AMENDMENTS TO THE DRAWINGS:

REMARKS

FIG. 1(PRIOR ART)

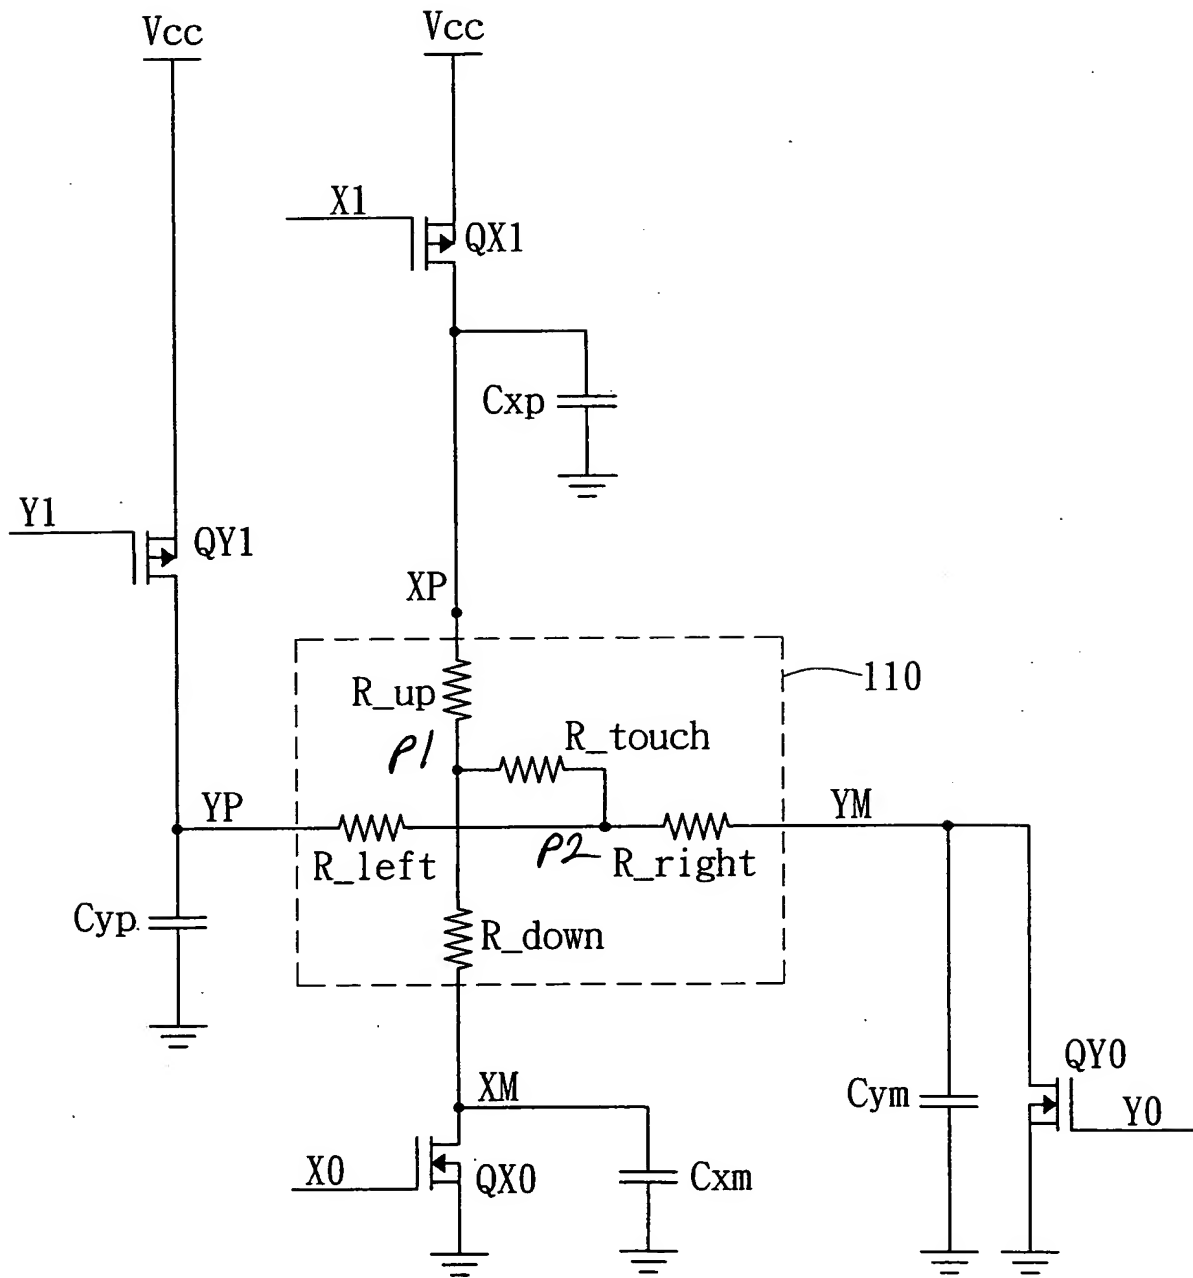
In the drawings, Figs. 1, 2A, and 2B are amended to add the labels “P1” and “P2” at each end of resistor “R_{touch},” and Fig. 5 is newly added.
